STAFF RECOMMENDATION

1419 Holly Street

Application: Demolition and Infill

Description of Project: The proposed project is to demolish an existing non-contributing building at the rear of a lot at the corner of Holly and North 15th Streets and to construct a new attached duplex that will read as two single-family homes connected by an eight foot by sixteen foot (8' x 16') connector that will appear to be a fence as seen from North 15th Street.

EXISTING BUILDING

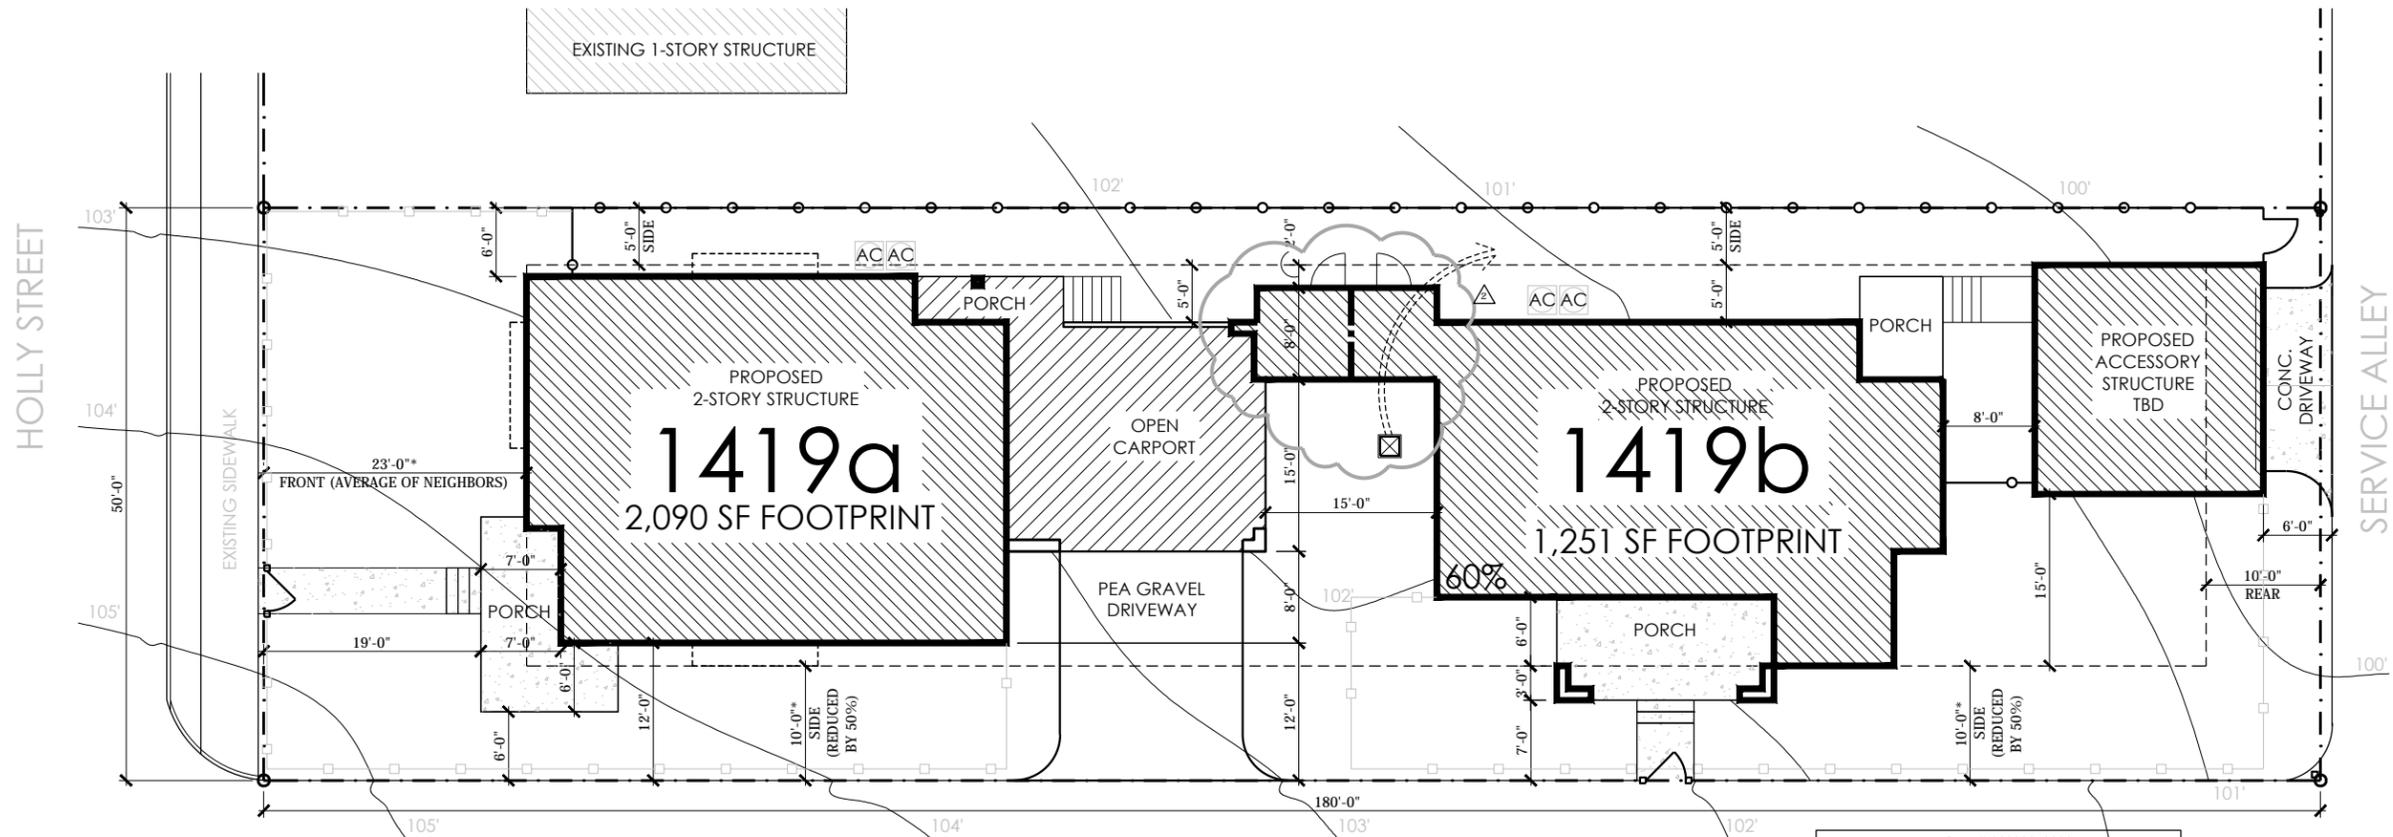
Demolition: This lot has been empty, at least since 1914. (See 1914 Sanborn Fire Insurance map to the right.) At the rear of the lot sits a c.1950 secondary dwelling that has undergone multiple alterations. It first appears on the Sanborn Fire Insurance maps and in the city directories in 1951. The foundation is concrete block, the siding Masonite and the roof asphalt

shingle. Since it was constructed outside of the period of significance for the overlay and does not contribute to the historic character in terms of style or construction method, staff finds demolition is appropriate and meet section III.B.2.

A1 ARCHITECTURAL SITE PLAN
SCALE: 1/16"=1'-0"

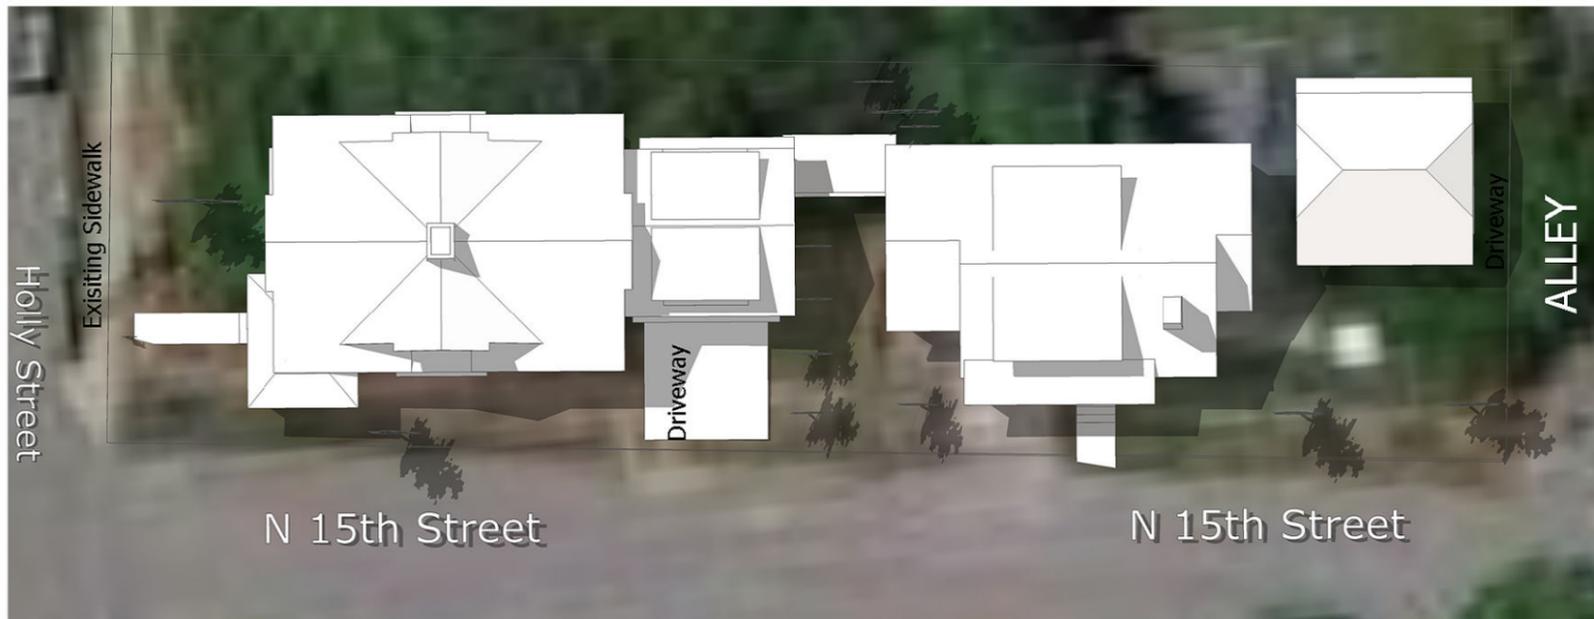
Vehicular access for the project is with a driveway leading from the alley to a two-car garage and a double-wide (16') pea gravel driveway leading from North 15th Avenue to a two-bay carport with conditioned space above. Typically, the commission has not allowed for street-facing garages, attached garages at any location other than a rear basement level, or new curb cuts. In addition, research of corner lots with two homes revealed that this type of development either had no garage or only one garage for the two dwellings. Staff recommends replacing the proposed carport with a parking pad. In addition, Staff suggests that the curb cut be narrowed to one lane; however, that may not be feasible since vehicles from this parking area would need to back out. Staff therefore recommends a new design for the driveway that incorporates a product such as turf-pavers and concrete strips to minimize the impact of the width. With these conditions, the project meets section II.B.6.

However, the proposed carport is located at the center of the lot and attached to the house. The proposed is more than a simple carport with four posts and a roof, as this carport has substantial corners, potentially allowing for garage doors to be installed at a later date, and a second-story conditioned space. As stated prior, Staff recommends replacement of the middle carport with a parking pad and that windows be added to the exposed north elevation. With these conditions, the project meets section II.B.8.

1. Staff provide final review of windows and doors;
2. The carport be replaced with a parking pad and that windows be added to the newly exposed north side of the building; and
3. The North 15th Street driveway be redesigned to either be one lane of concrete strips or appear to be one lane by using a product such as turf-pavers.
